STAFF RECOMMENDATION

**0 Forrest Avenue
January 18, 2012**

Application: Infill

Description of Project: 0 Forrest Avenue is a vacant interior lot (no street frontage) with street access on Lakehurst Avenue. Applicant proposes to construct two detached two-story single-family dwellings.

SITE PLAN

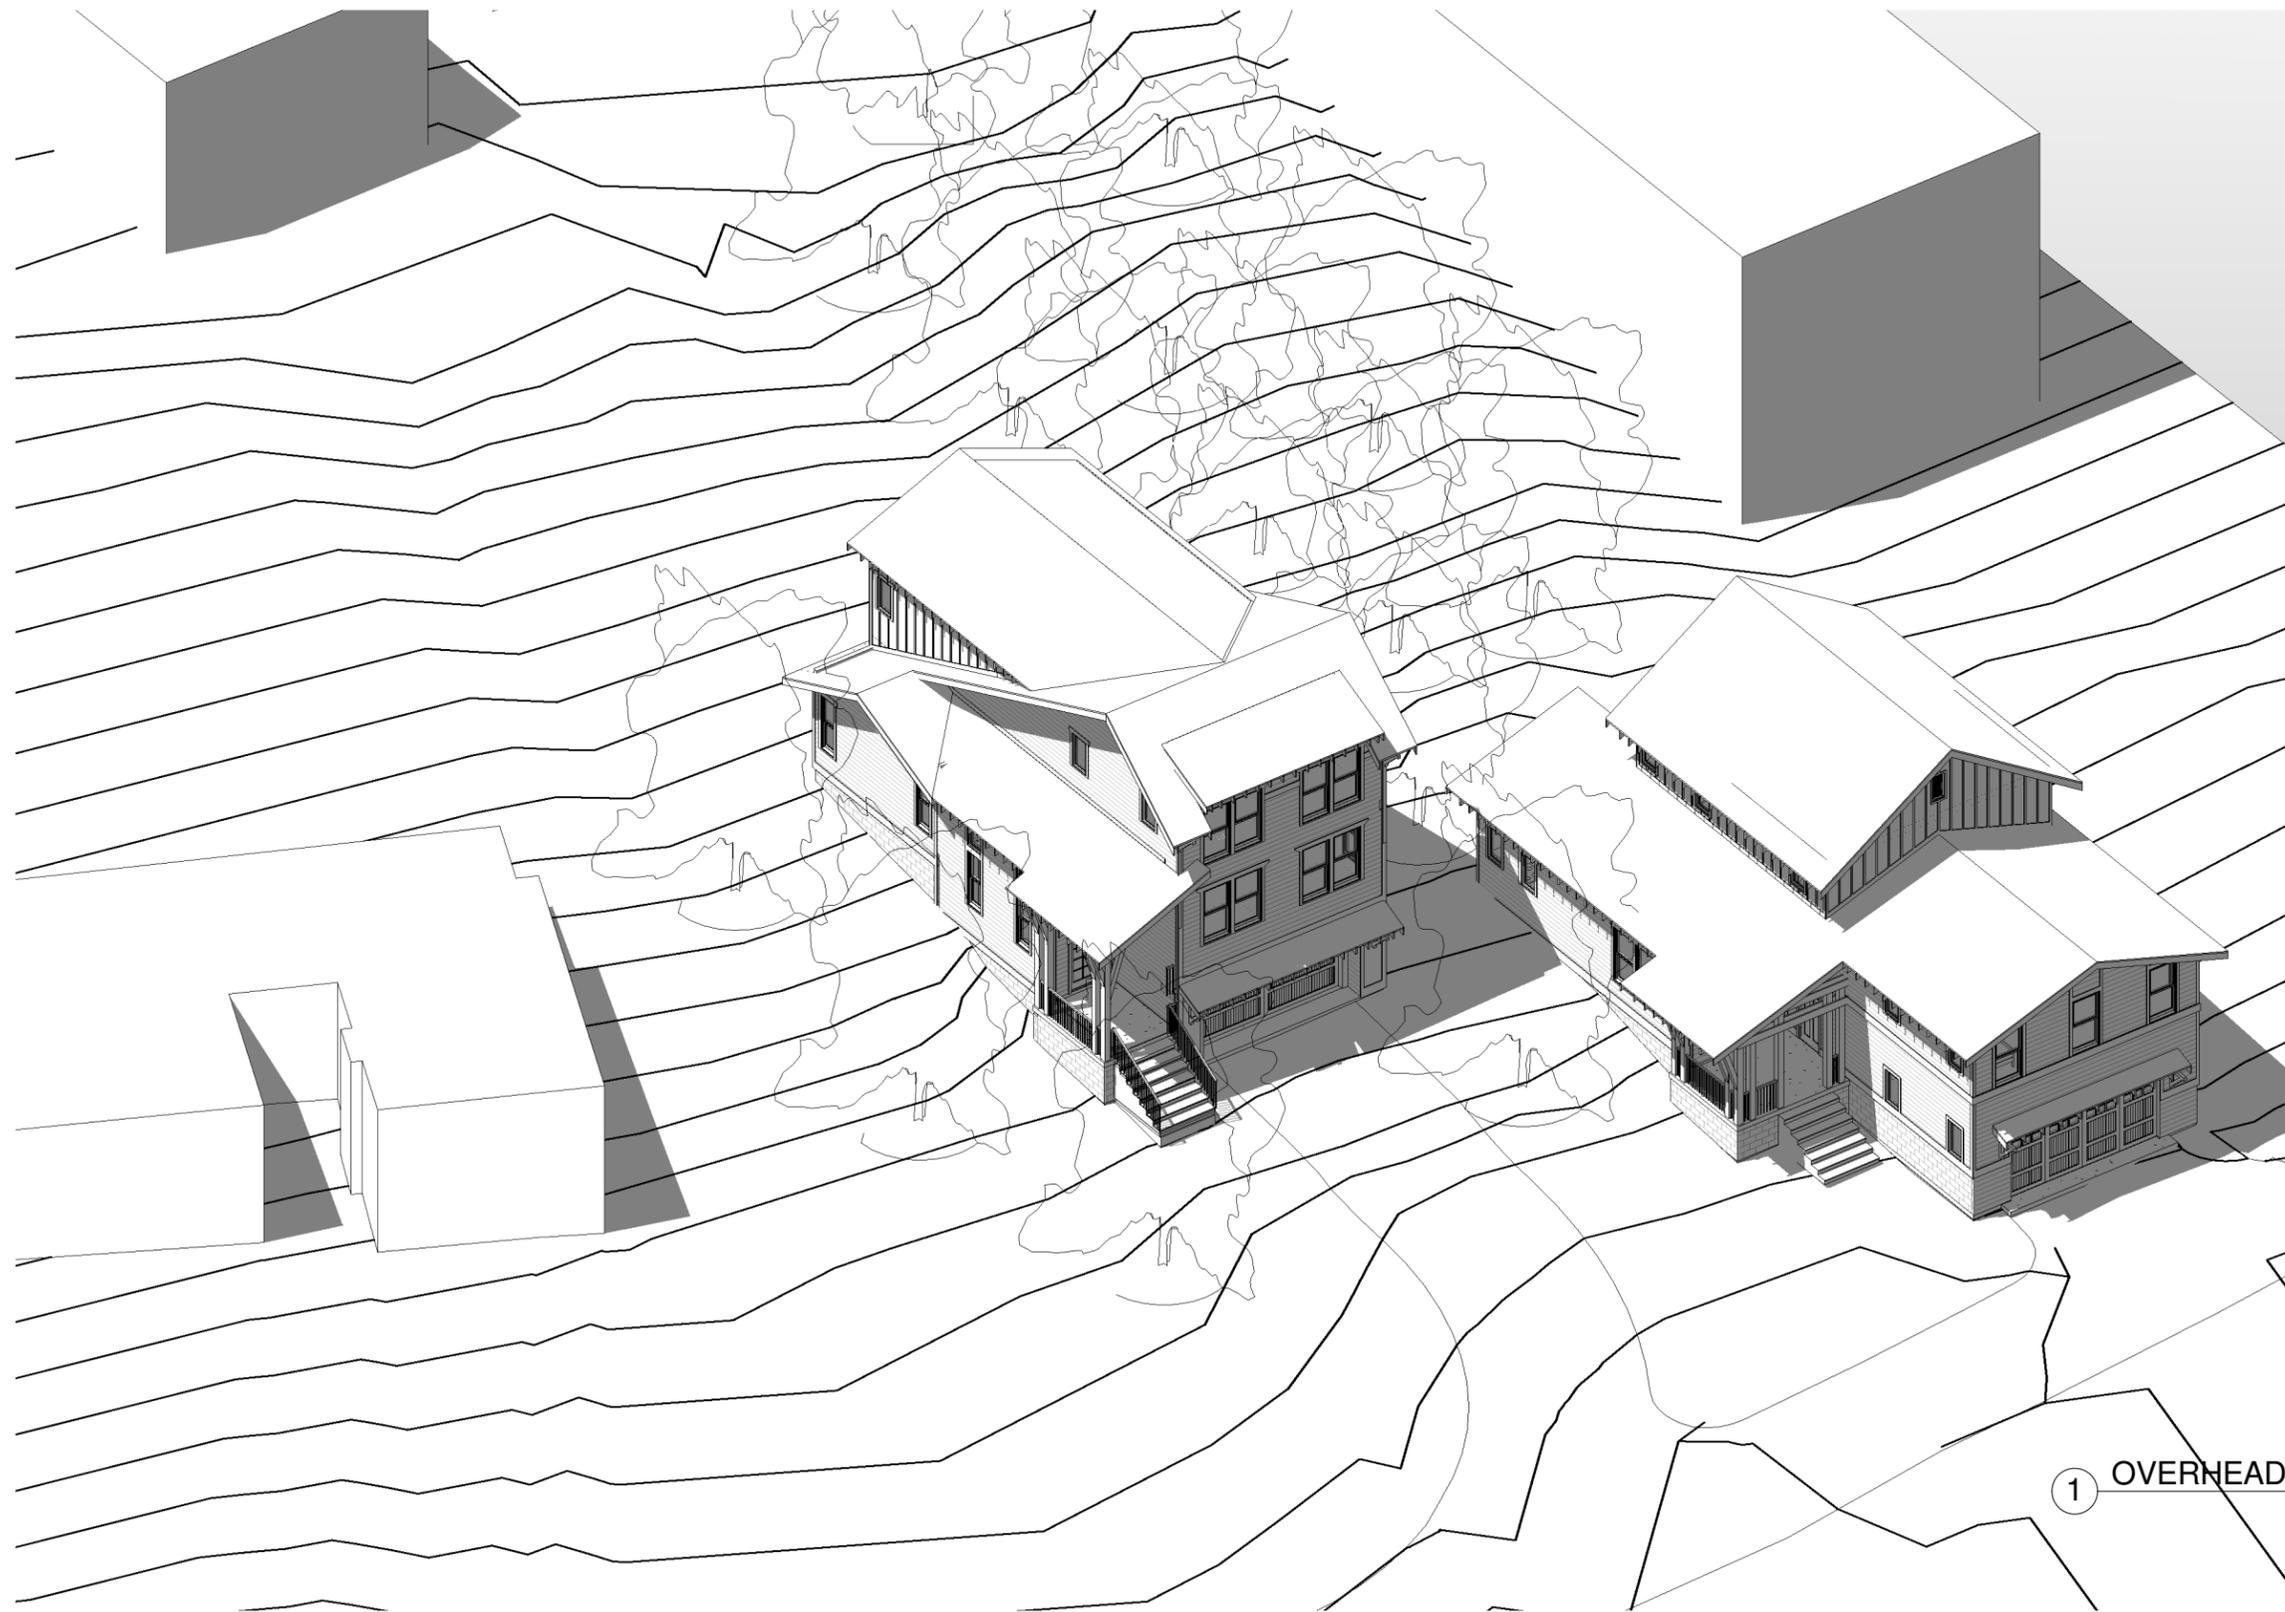
Appurtenances: The proposed driveway is located in the only area that provides access to this lot from a public street and is therefore appropriate. It will be approximately eighteen feet (18') across and adjacent to an existing driveway for the new construction facing Ordway. Staff recommends that the entrance of the driveway be no more than fourteen feet (14') across, at least from Lakehurst to the main property line, to minimize its impact on Lakehurst. (Fourteen feet (14') has been approved by Public Works.) It will be asphalt, as required by the Public Works. There are no known plans for any fences or walls at this time.

Staff recommends approval with the condition that the applicant seek final approval from staff for windows, pedestrian and vehicular doors, and roof color and that the driveway width be no more than fourteen feet (14'). Staff finds that the project meets II.B of the *Lockeland Springs-East End Neighborhood Conservation District: Handbook and Design Guidelines* for new construction.

ELEVATIONS

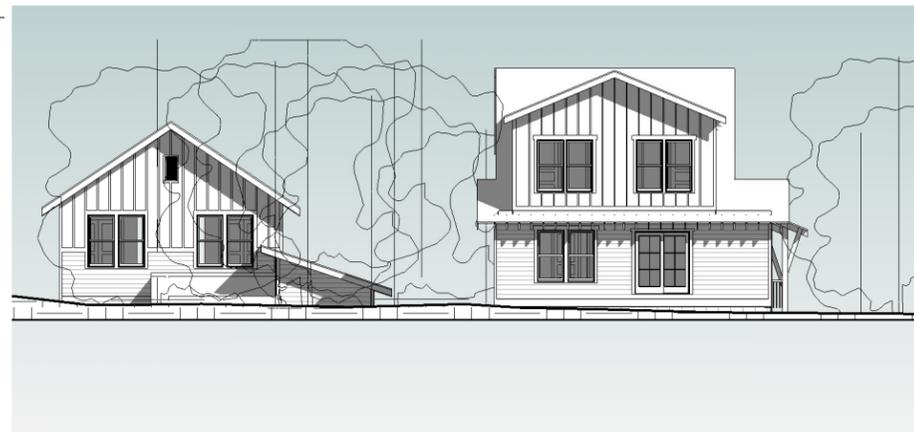
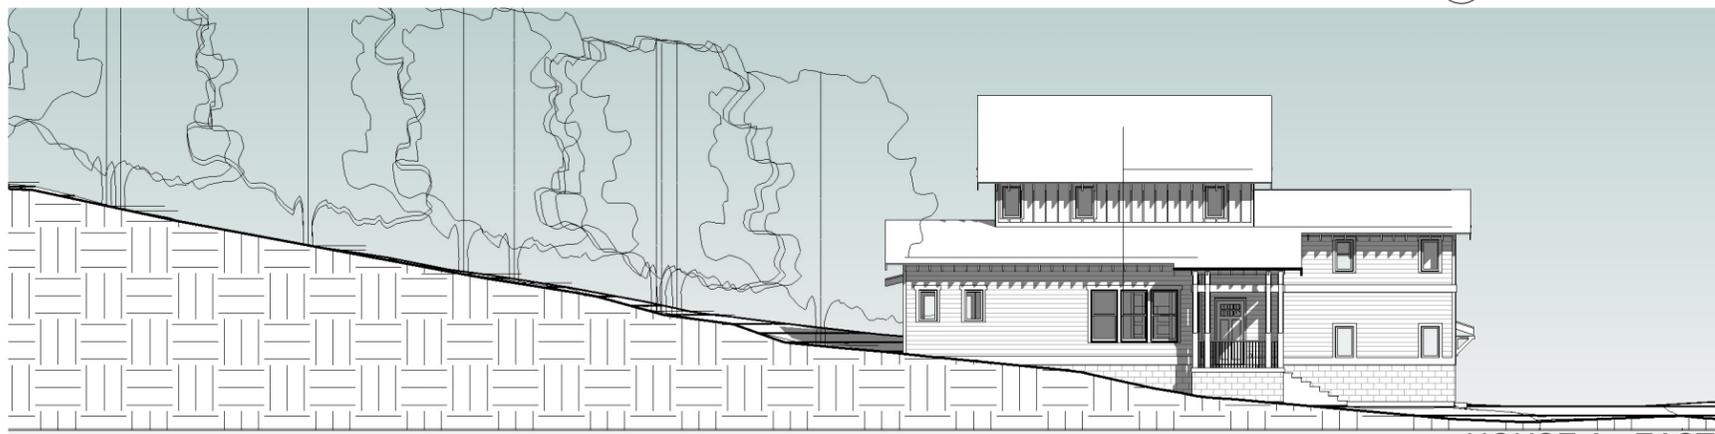
Height & Scale: The grade gradually drops from south to north by a total of approximately twenty-five feet (25'). Because of the grade, the two homes vary between two and three stories. The height varies from approximately twenty-four and twenty-six feet (24'-26') from ridge to the highest grade and between approximately thirty-one and thirty-four feet (31'-34') from ridge to the lowest grade. Foundation height varies from at-grade to as many as seven blocks in height. Historic buildings in the immediate area are mostly one-story but do rise to two stories because of the grade. True two-stories are also prevalent in the surrounding neighborhood, if not in the immediate context. The tallest buildings adjacent to the lot are new construction, are two-stories and are between twenty-one feet (21') and twenty-four feet (24') tall. Because of the extreme grade change, staff finds the heights to be appropriate and meet section II.B.1 of the design guidelines.

Proportion and Rhythm of Openings: In the past, the Commission has required for openings to be generally between eight and thirteen feet (8'-13') apart in order to match the rhythm of openings found in the historic context. In this case, there is no instance where openings on either building are more than thirteen feet (13') apart. Staff finds that the project meets section II.B.7 of the design guidelines.

Materials: Materials include a painted CMU foundation; cement-fiber lap siding and board-and-batten; composite trim; wood porch railing and posts; and an asphalt shingle roof. The color of the roof and material of windows and doors is unknown at this time. All known materials are appropriate and have been approved by the Commission in the past. Staff recommends final approval of windows, pedestrian and vehicular doors, and roof color be given by staff. With this final approval, the project will meet section II.B. 4 of the design guidelines.

Roof Shape: The roof lines for the proposed buildings are gables at various pitches, mainly 5/12, 8/12 and 10/12 and shed roofs with pitches of 4/12 and 5/12. Historically, a gabled roof usually has a pitch of at least 6/12; however, because of the minimal visibility of these two structures, this one degree of difference will not negatively impact the historic character of the district. The roof shape of both buildings meets section II.B. 5 of the design guidelines.
